STATE OF MAINE
DEPARTMENT OF TRANSPORTATION
16 STATE HOUSE STATION
AUGUSTA, MAINE 04333-0016

January 13, 2023
Subject: Main St. Bridge
Replacement
State WIN: 022260.01
Location: **Solon**
Amendment No. 4

Make the following changes in the Bid Documents:

STATE OF MAINE DEPARTMENT OF TRANSPORTATION		2189401		WIN 022260101	
BRIDGE NO. 2504		BRIDGE PLANS			
MAIN STREET BRIDGE FALL BROOK		SOMERSET COUNTY		SOLON	
REINFORCING STEEL SCHEDULE		SHEET NUMBER		64	
OF 66

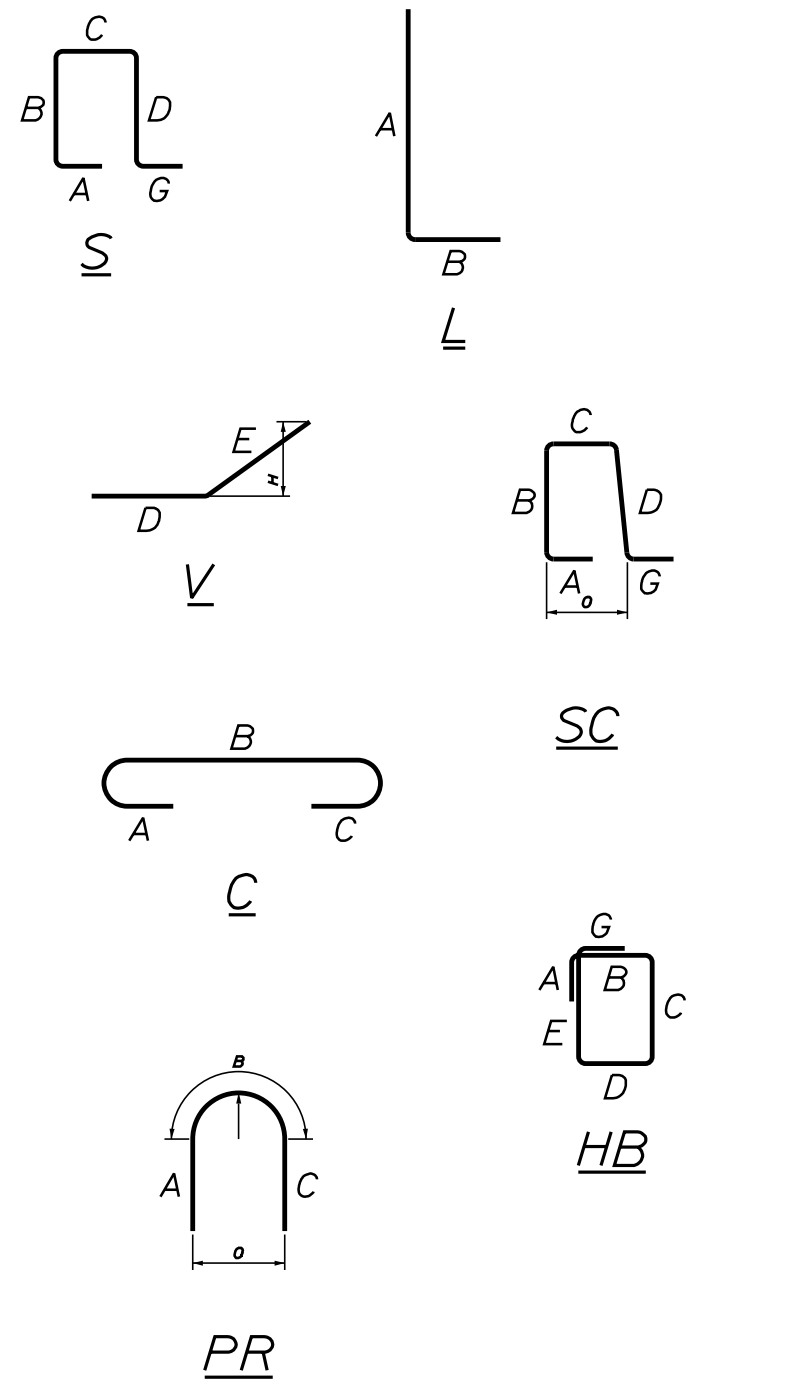
Remove Sheet 64 of 66, Reinforcing Steel Schedule dated Nov 2022 and **Replace** with the attached Sheet 64 of 66, Reinforcing Steel Schedule with Revision 1 dated 1/11/2023.

TYPICAL SUPERSTRUCTURE SECTION
Composite Girder Bid Alternate

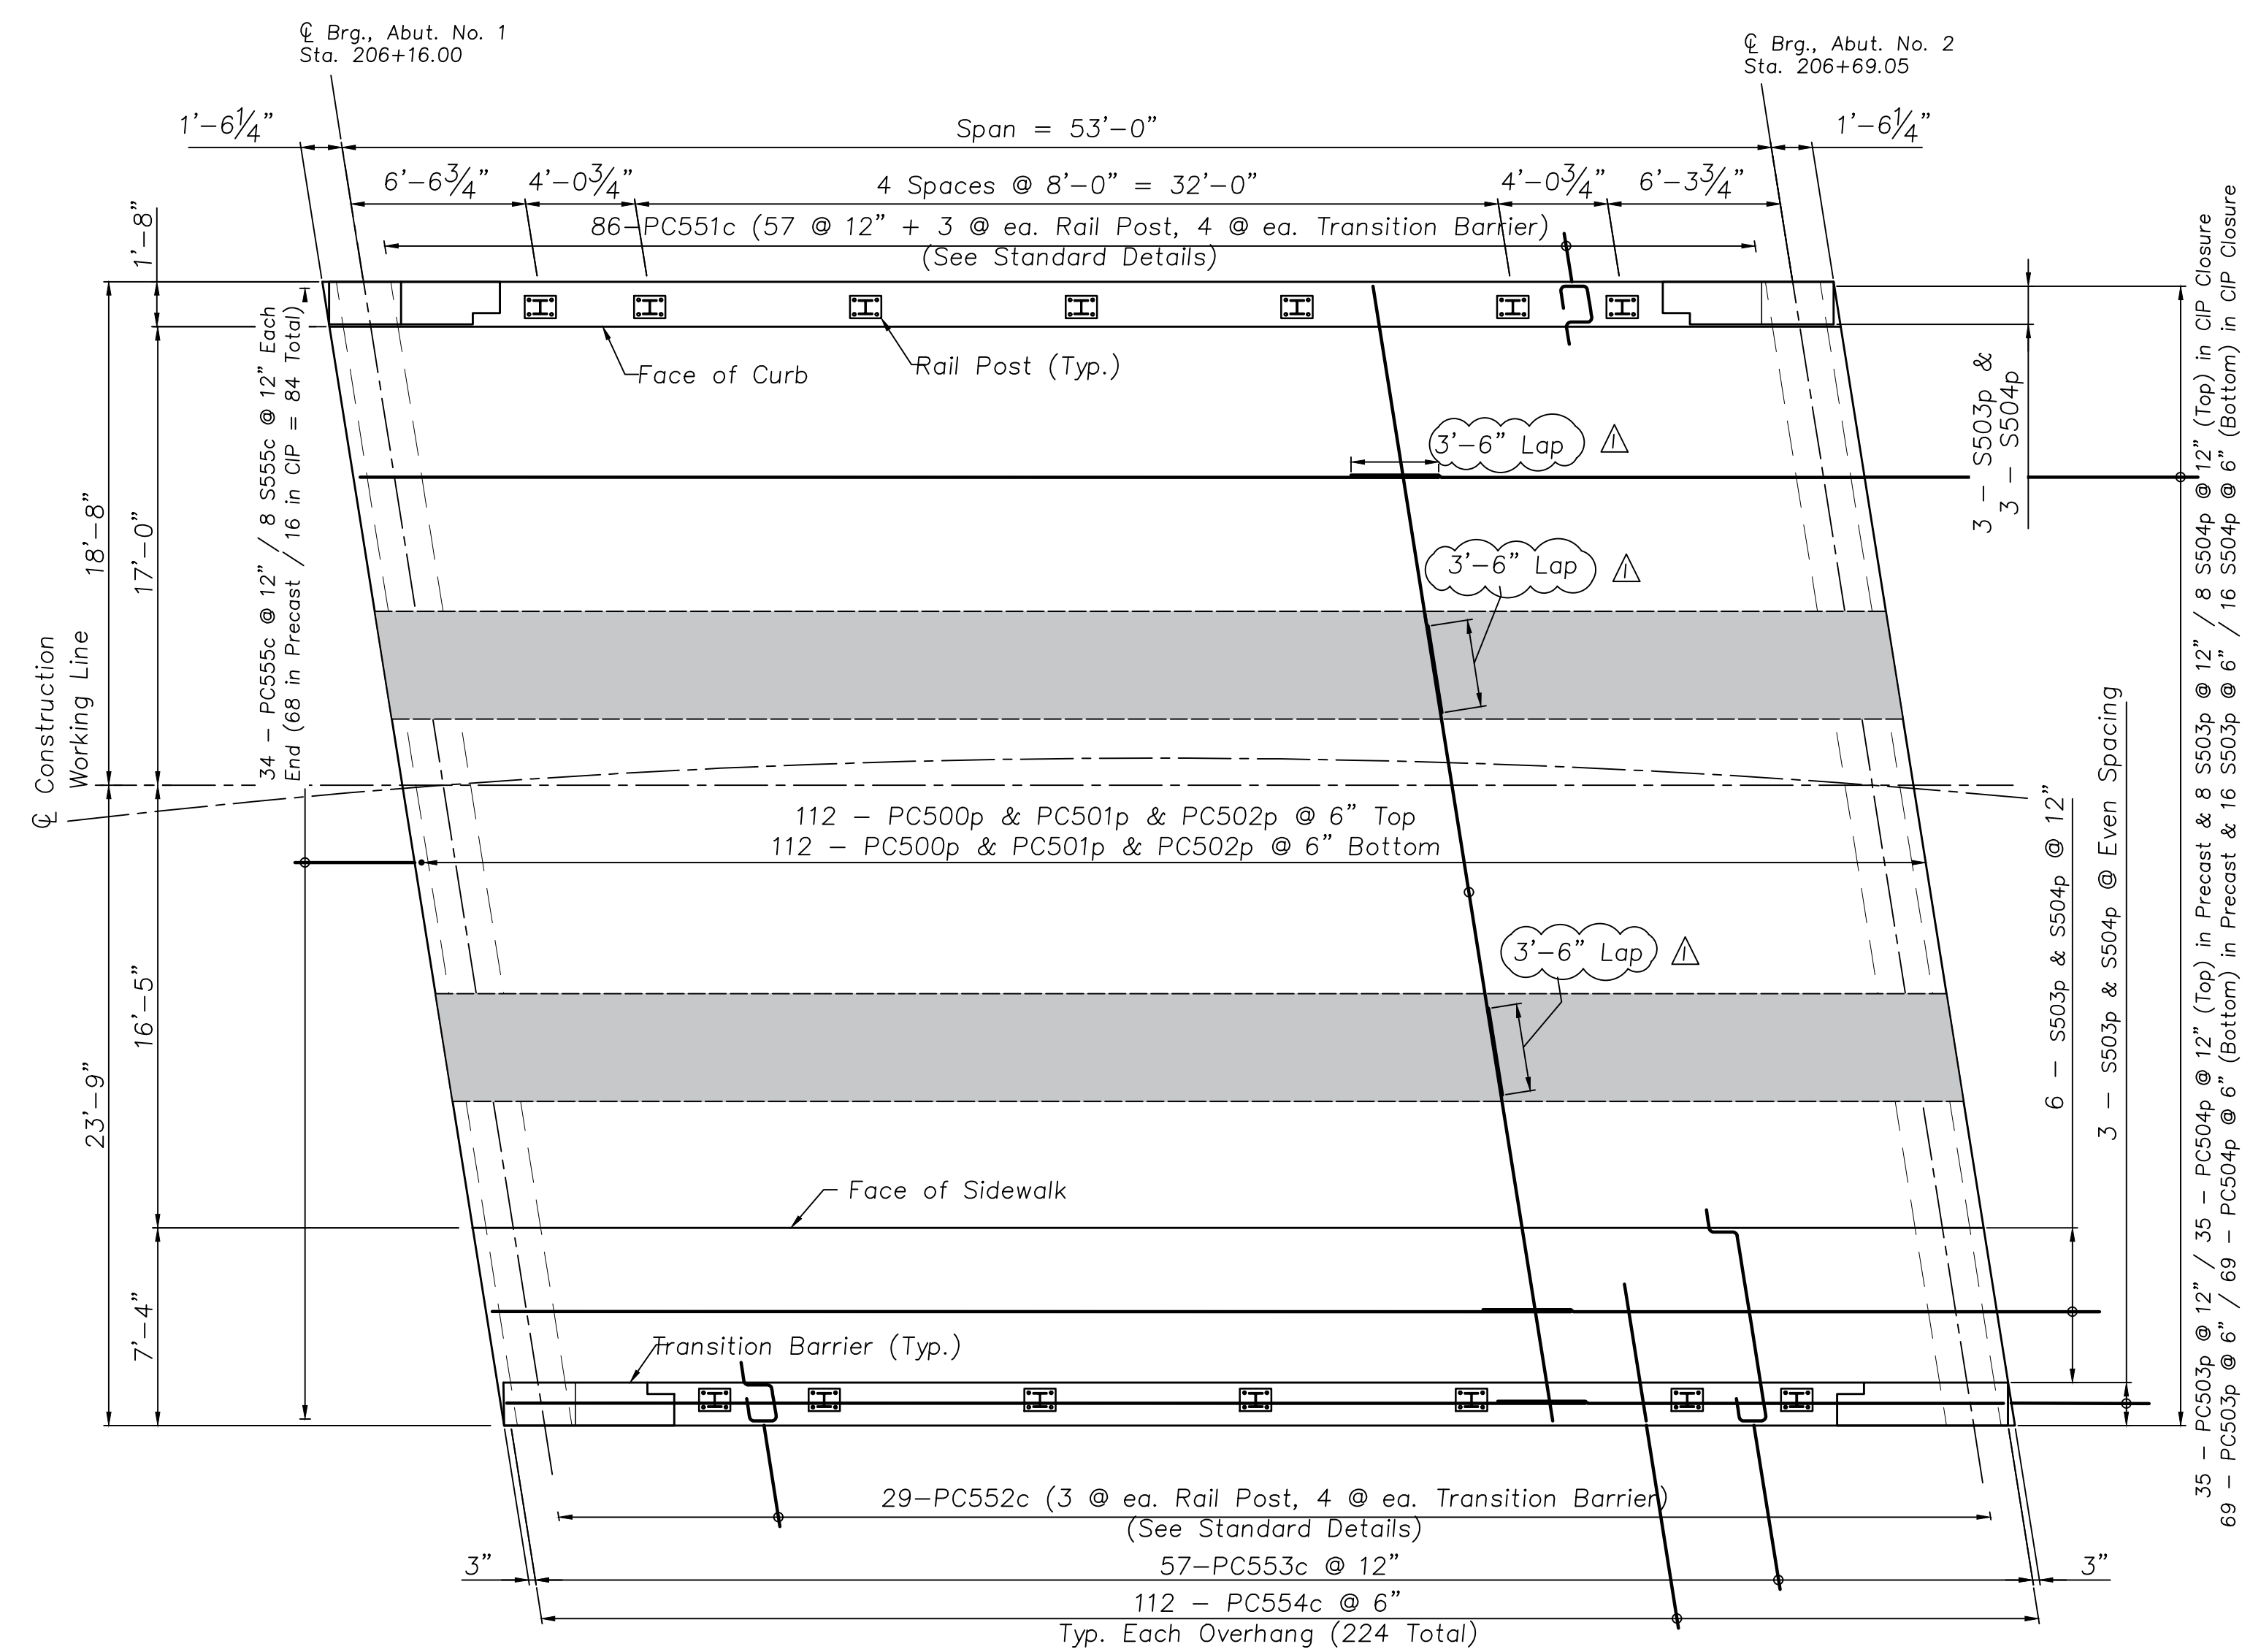
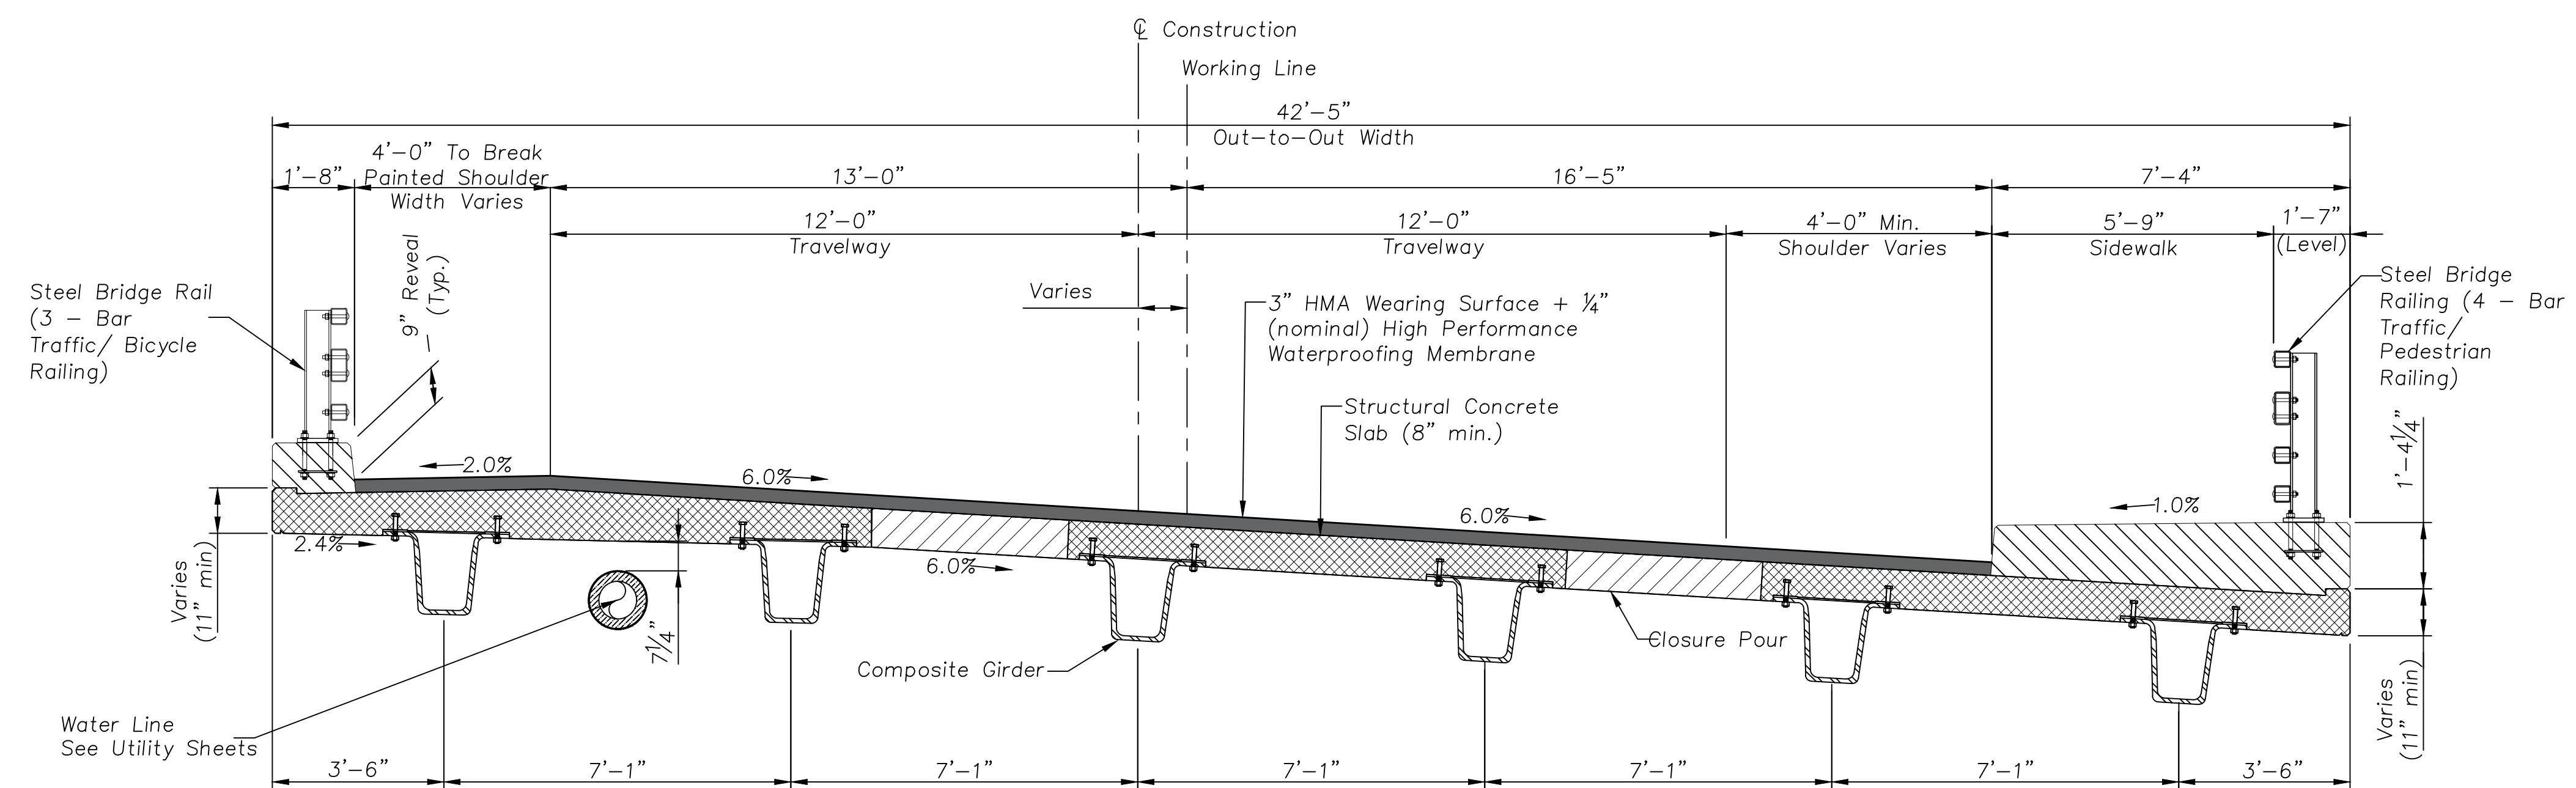
Remove Sheet 8C of 10C, Superstructure Section & Notes dated 11/09/22 and **Replace** with the attached Sheet 8C of 10C, Superstructure Section & Notes with Revision 1 dated 1/12/2023.

Question: Will the Department allow the use of lightweight concrete for precast elements, provided the mix design meets the specifications?

Response: Yes, Lightweight Concrete will be allowed for the precast elements. If Lightweight Concrete is used in the precast elements, it must also be used for the cast-in-place closure pours in the deck.

- Precast deck and closure pour concrete may be all normal weight concrete or all lightweight concrete. The combination of normal weight and light weight concrete will not be permitted.
